22 August 2011

**MP 10_0112 & MP 10_0113 Mixed Use Development at 110-114 Herring Road,
Macquarie Park**

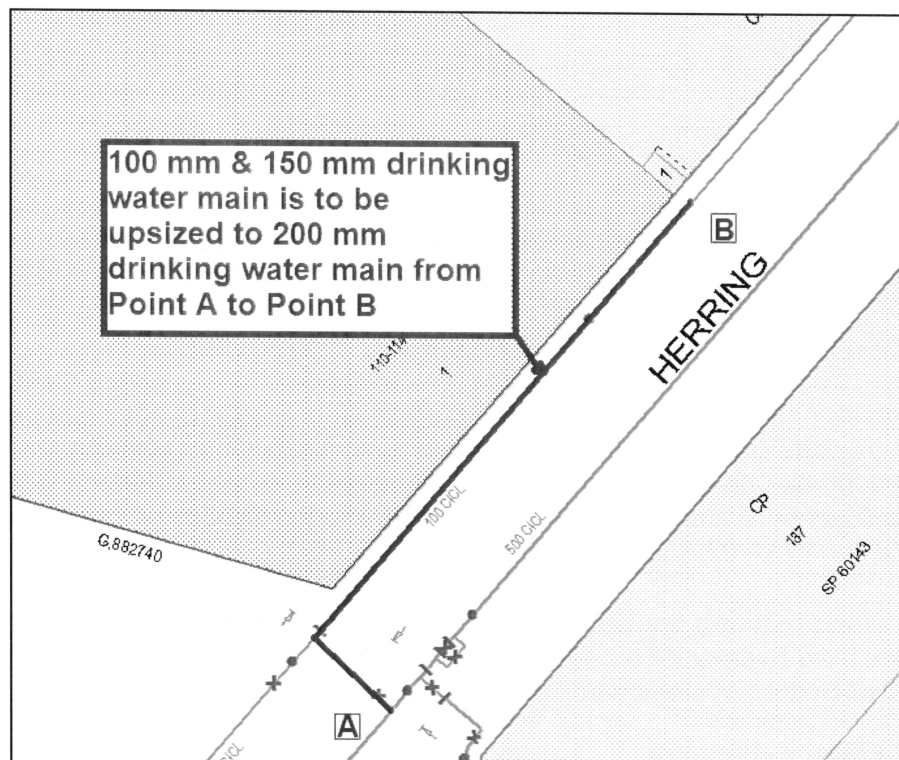
The 100mm and 150mm drinking water mains need to be upsized to a 200mm main from point 'A' to point 'B' on the plan below ('B' is 2 metres past the point of connection).

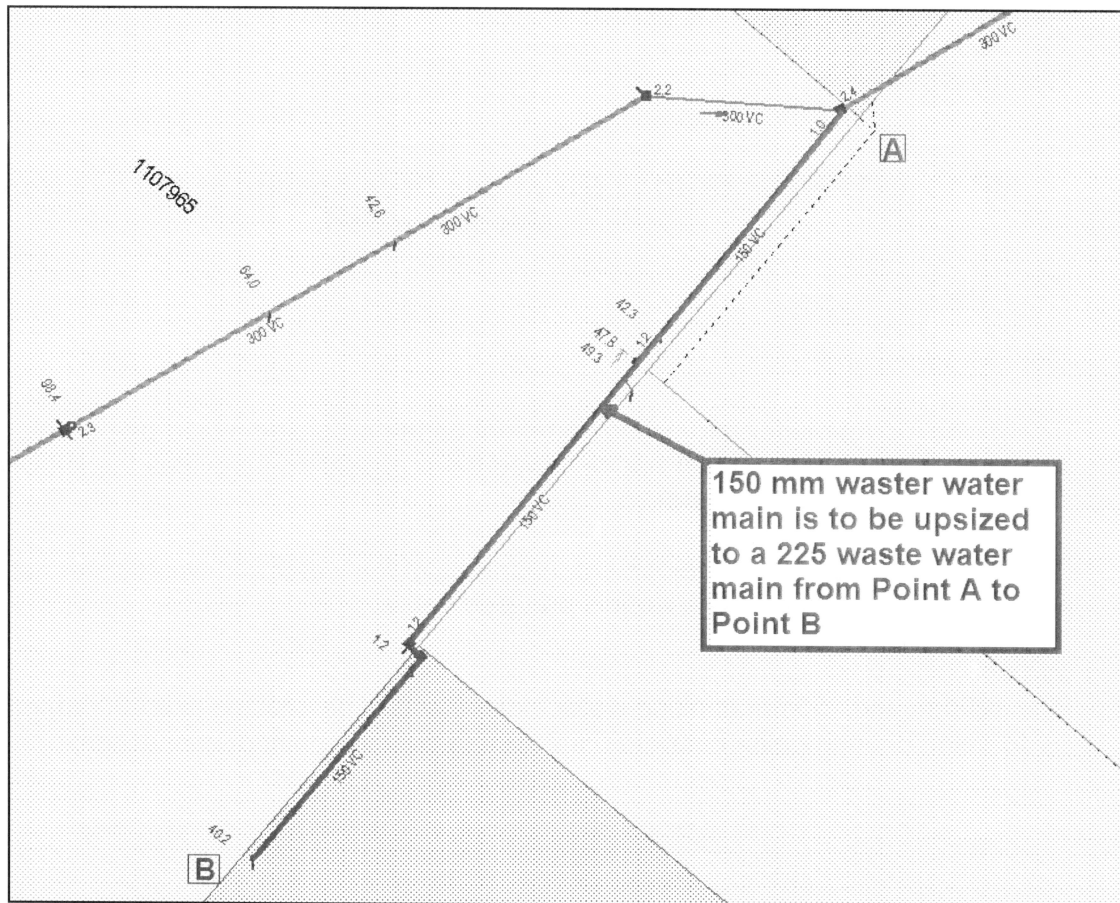
The existing 150mm wastewater main located to the north west of the site is to be upsized to a 225mm wastewater main from 'A' to 'B' on the diagram below.
